# Access Compliance Report

## Public Rights-of-Way

Intersection ID: N/A	Main Street: 7TH_ST	Cross Street: N/A	Location: SW
ADA ID: AB07C14E180D	Ramp Type: PerpDiag	Initial Pass/Fail: Pass	Overall Compliance: No
		Severity Score: 0.25

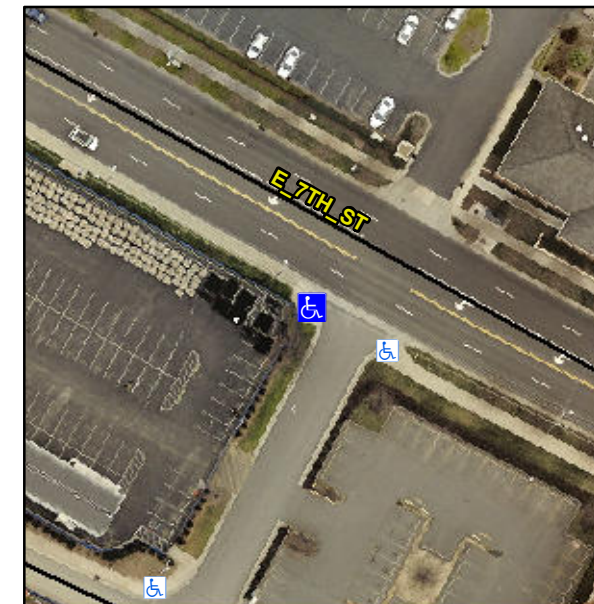
**R304.5.3**

Compliance	Description	Data	Compliance	Description	Data
N/A	Ramp Length (in)	60.0	Yes	Ramp Slope (%)	5.7
Yes	Ramp Width (in)	48.0	No	Ramp XSlope (%)	4.4
N/A	Flare Type LT	Sloped	N/A	Flare Type RT	N/A
N/A	Flare Slope LT (%)	7.8	Yes	Flare Slope RT (%)	1.8
N/A	Flare Traversable LT?	No	N/A	Flare Traversable RT?	Yes
Yes	Landing Length (in)	60.5	Yes	DWS Provided?	Yes
Yes	Landing Width (in)	48.0	Yes	DWS Contrast?	Yes
Yes	Landing Slope (%)	1.1	Yes	DWS Length (in)	24.5
No	Landing X Slope (%)	3.6	Yes	DWS Full Width?	Yes
N/A	Landing Curb? (Y/N)	No	Yes	DWS Offset (in)	1.0
N/A	Shared Landing?	No			
Yes	Gutter Ponding?	No	Yes	Gutter Slope (%)	0.6
Yes	Gutter Lip Ht (in)	0.0	No	Gutter X Slope (%)	4.2
N/A	Painted X Walk1?	No	N/A	Painted X Walk2?	No
	X Walk 1 Direction	To SE		X Walk 2 Direction	To NE
N/A	X Walk 1 Width (in)	N/A	N/A	X Walk 2 Width (in)	N/A
	X Walk 1 Slope (%)	0.3		X Walk 2 Slope (%)	7.3
	X Walk 1 X Slope (%)	4.4		X Walk 2 X Slope (%)	0.3

**Remove & Replace Curb Ramp With Two New Directional Ramps or Equivalent. Remove & Replace Gutter.**
